# SERVICE BULLETIN

TR-7800

#834R2

SUBJECT: TR-7800 PULSE NOISE

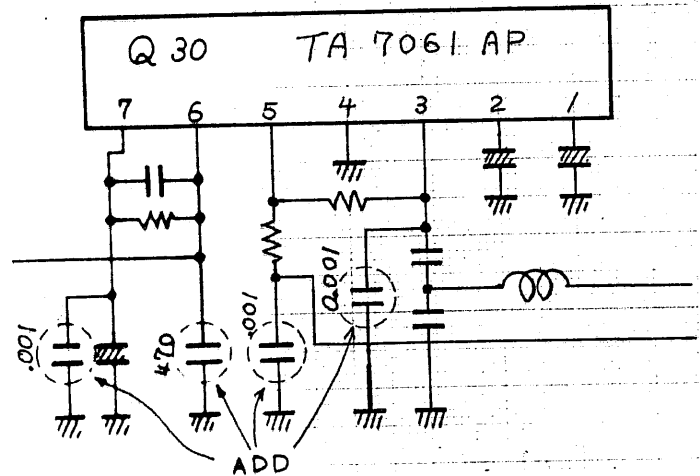
1. If not already present, install a shield (F11-0781-04) and two 1000pF capacitors (C52-1710-26) at the final amplifier module M57733 as shown.

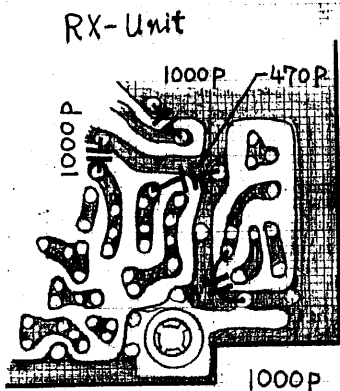
2. On the RX unit X55-1270-10 add three additional 1000pF caps (C52-1710-26) and one additional 470pF cap (C52-1747-16) as shown.
